# **ADDENDUM NO. 1**

## **HERITAGE PARK BOARD Heritage Park Amphitheater**

**February 14, 2019**

Re: Heritage Park Board  
Heritage Park Amphitheater

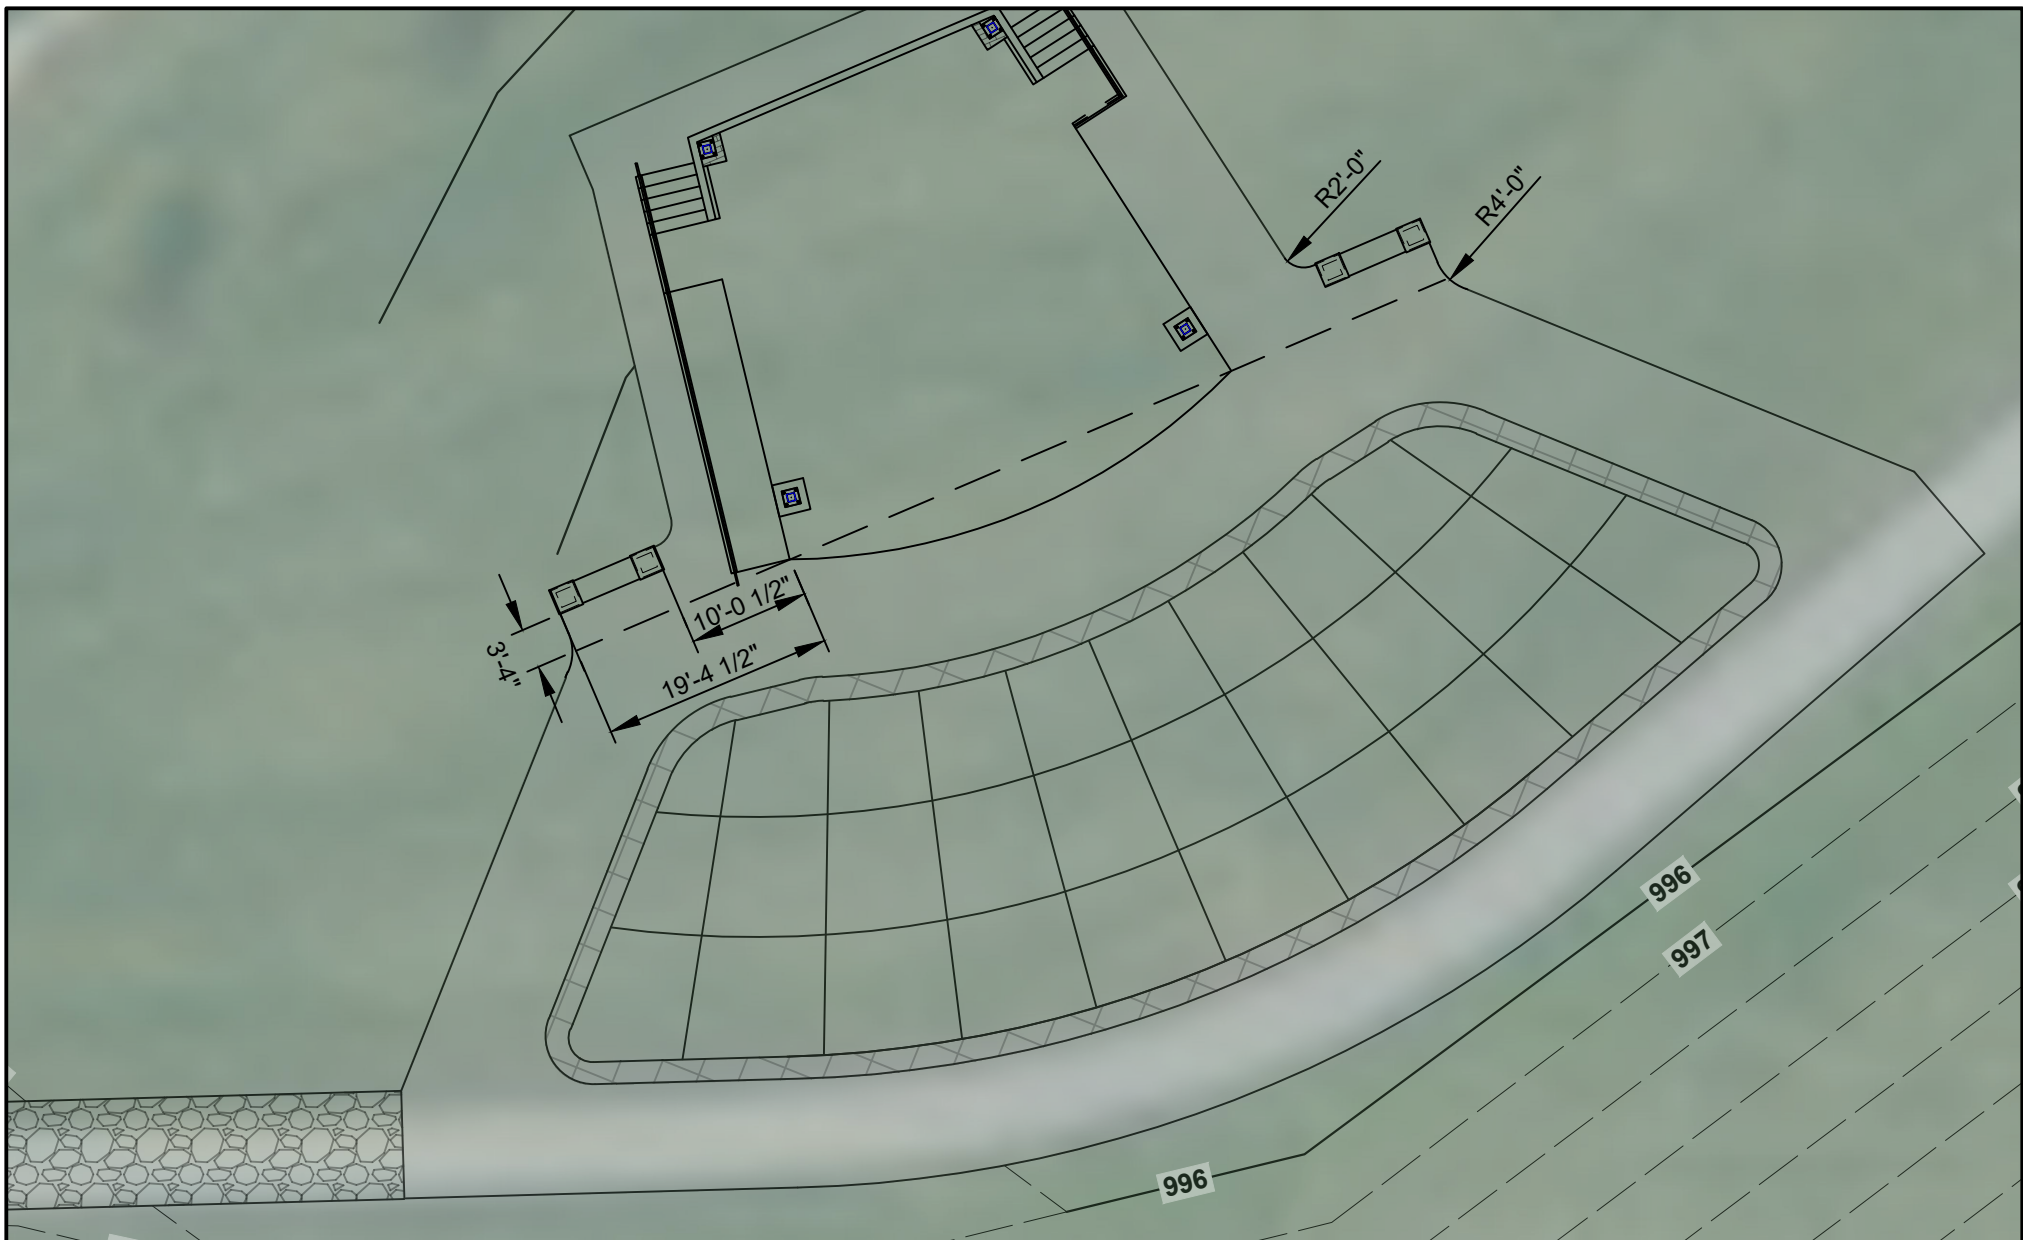
- a. Change the Title Block Sheet No. to read 2 OF 10.
- b. On the BASE BID SITE PLAN, the north sidewalk shall be 5 feet wide.
- c. Locate the Donor Benches and extend the concrete drive to them as indicated on attached sketch SK-1, DONOR BENCH PLACEMENT.

**ELEVATIONS**  
**HERITAGE PARK AMPHITHEATER**  
**YOLO OF DARKE COUNTY, INC.**

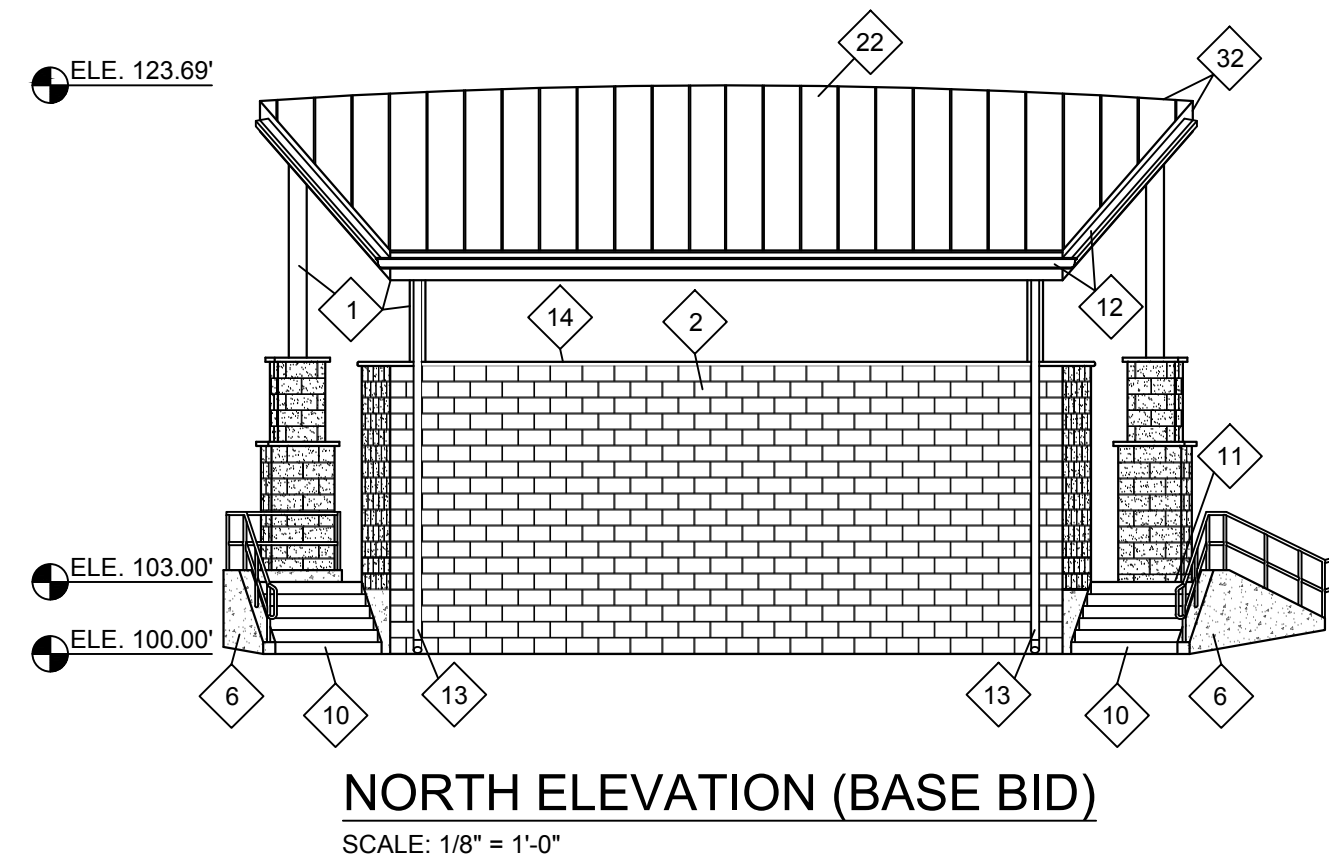
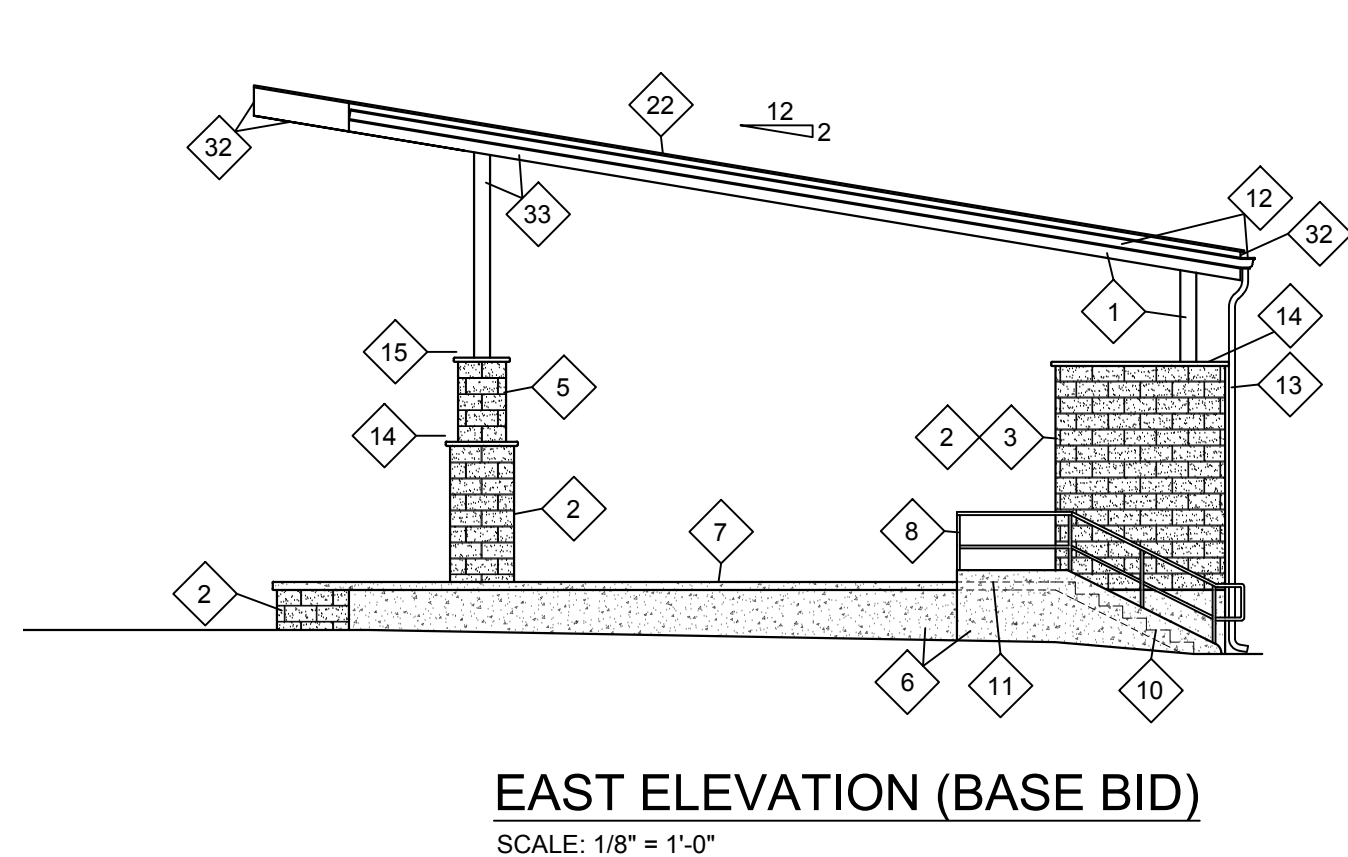
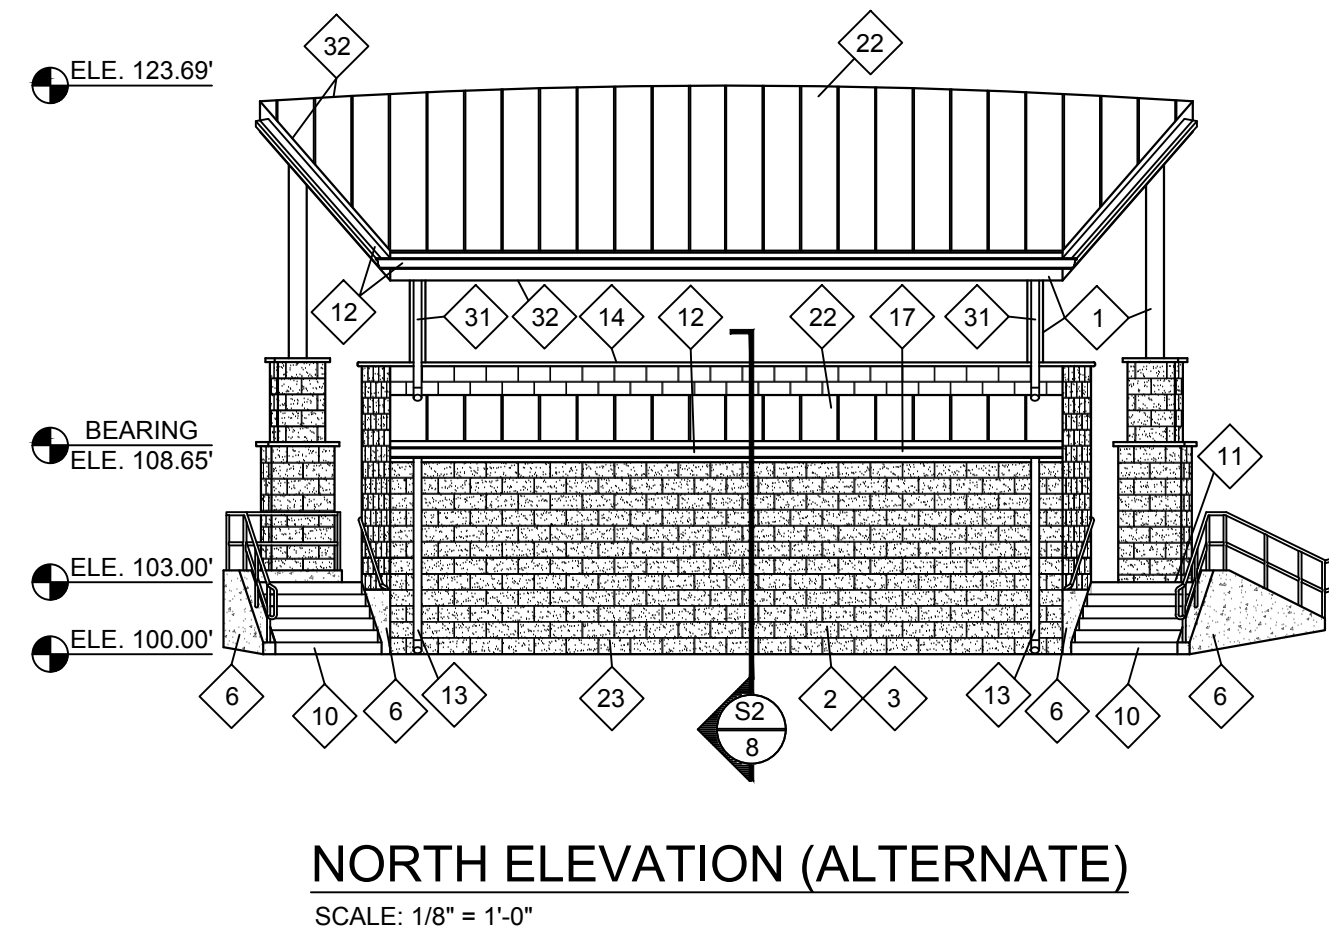
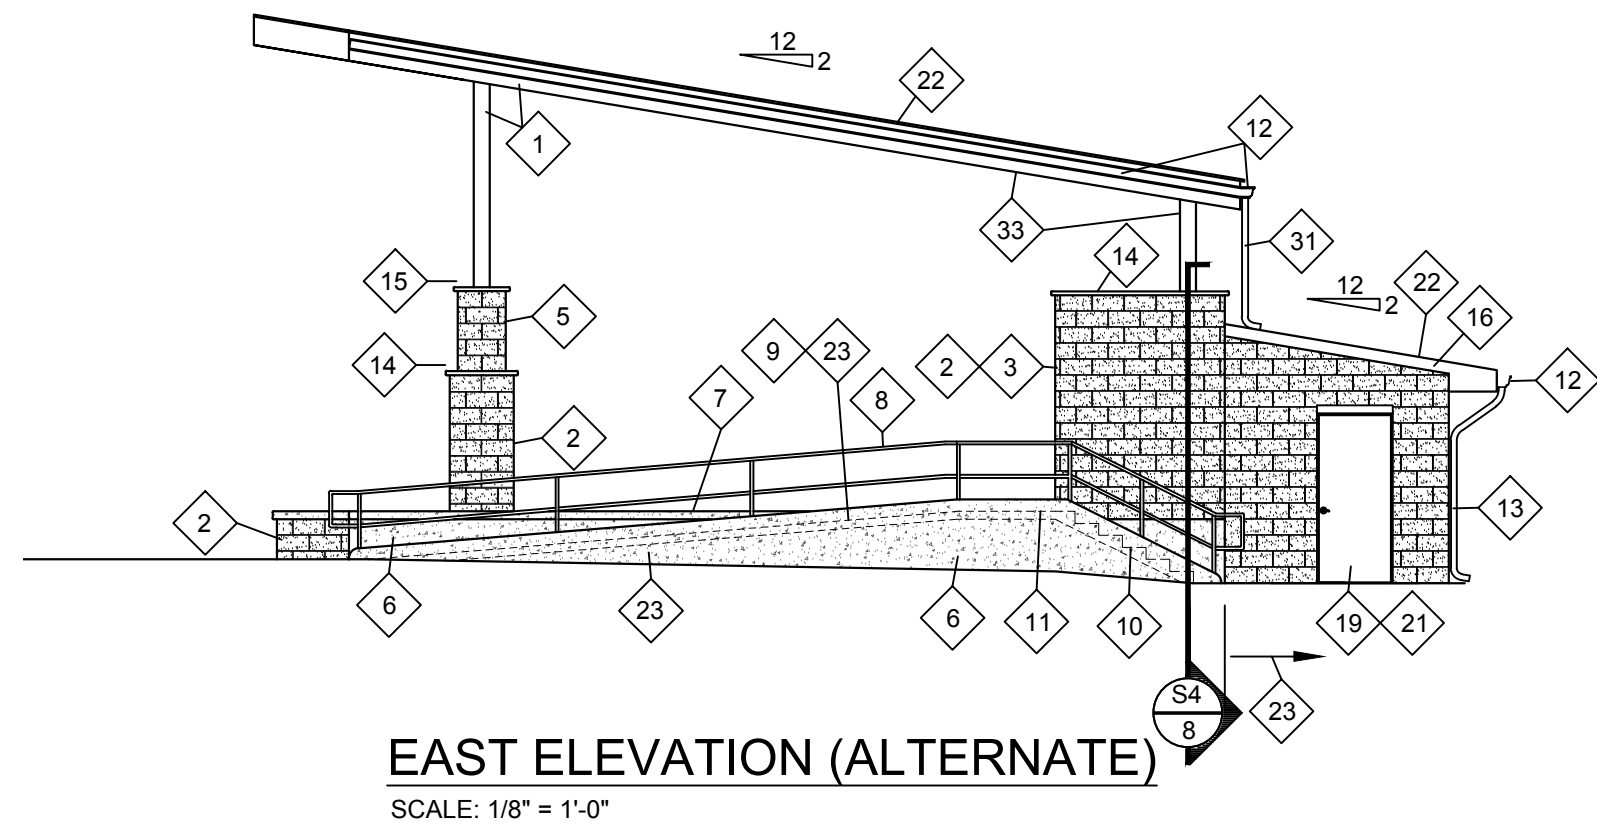
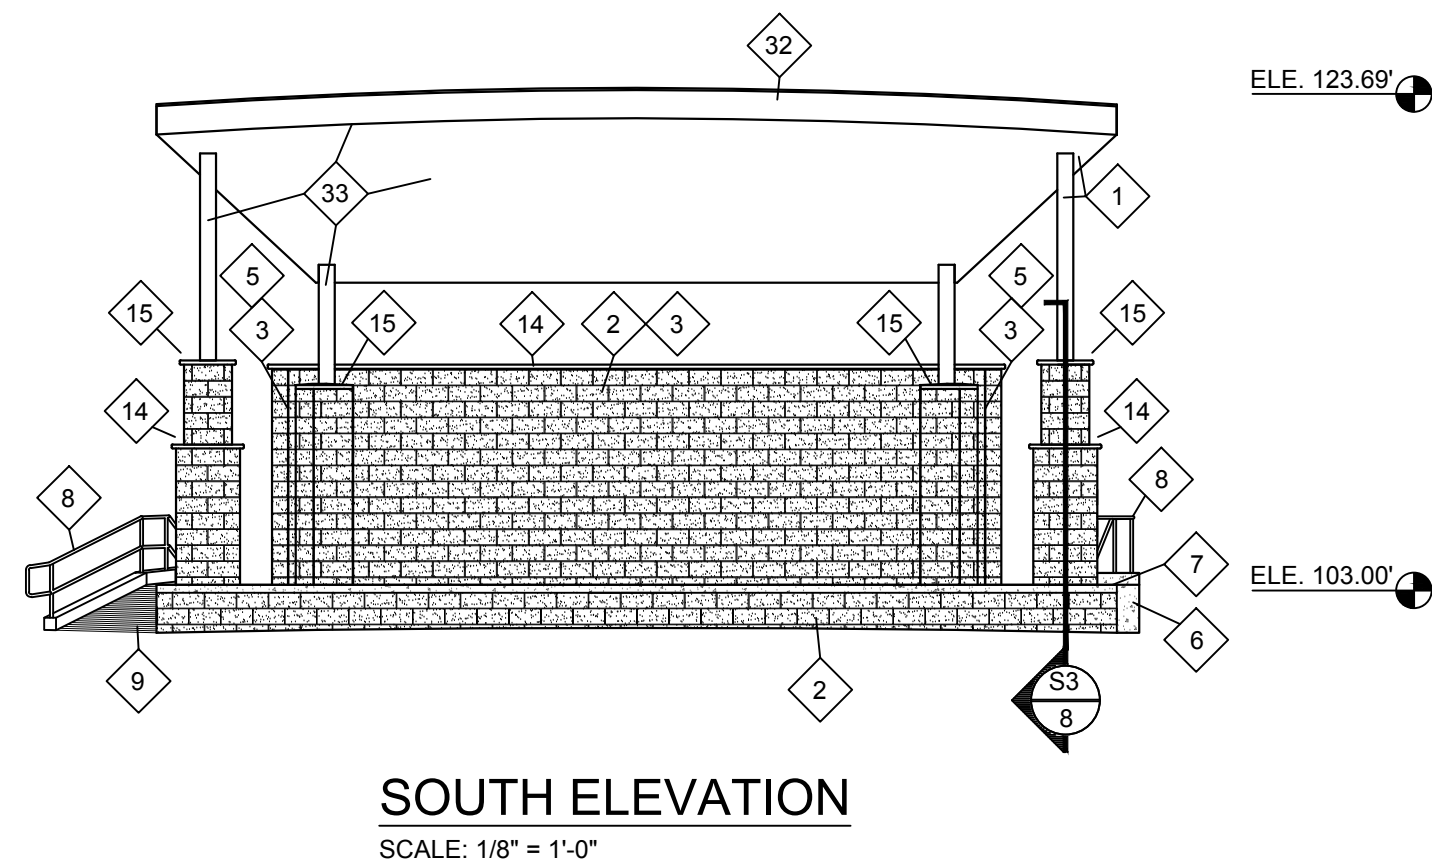
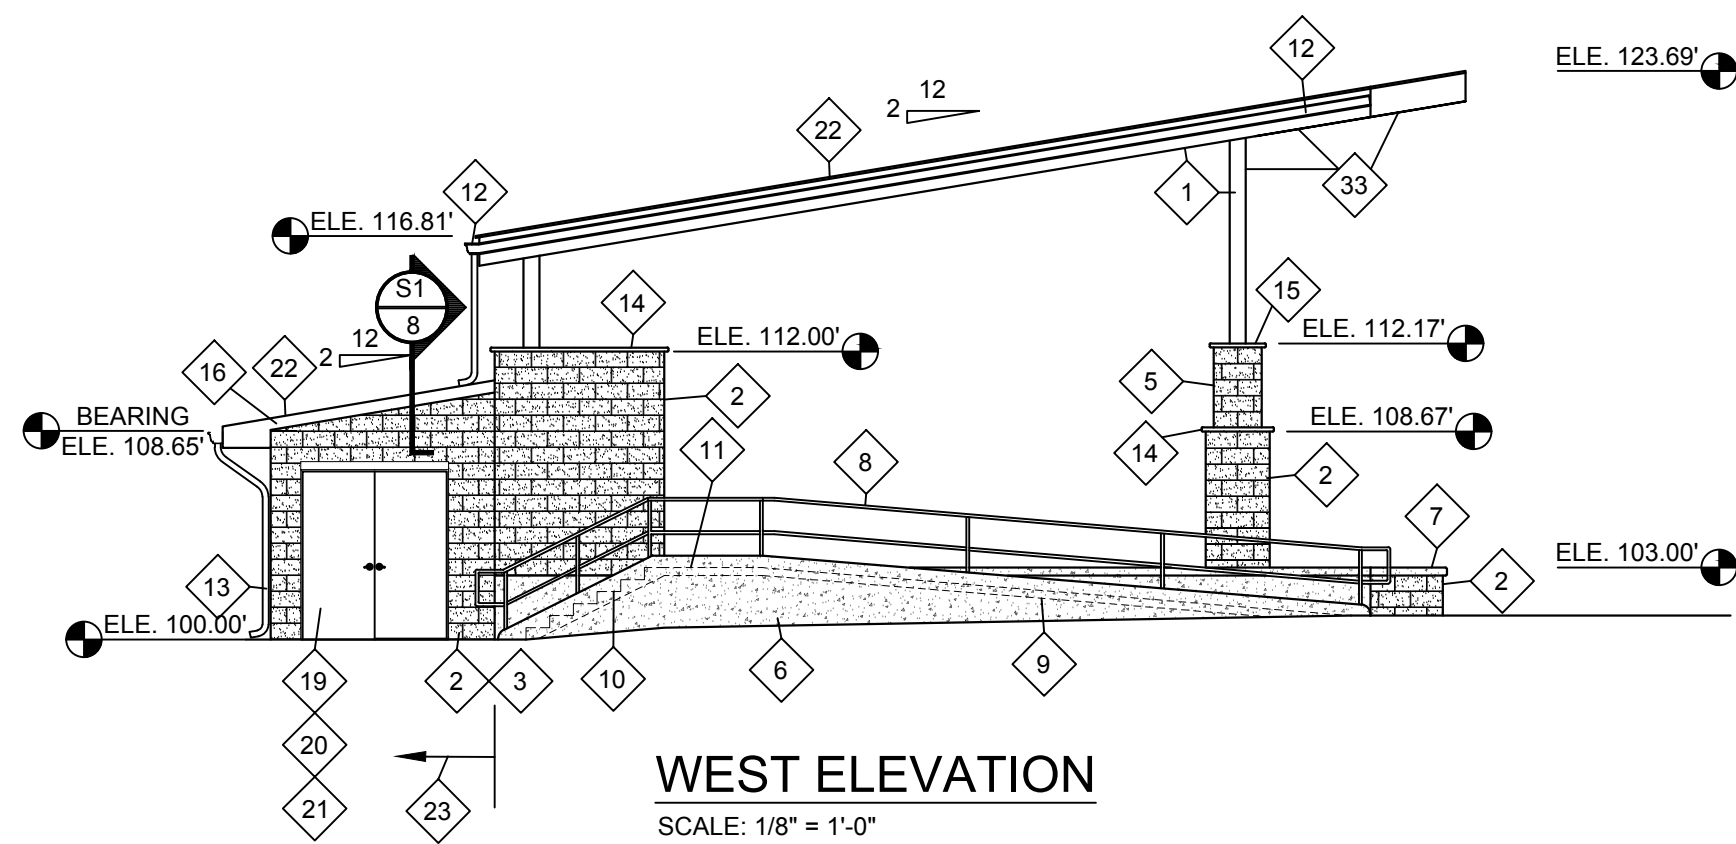
- a. Replace this Drawing with attached revised Drawing 8R OF 10.
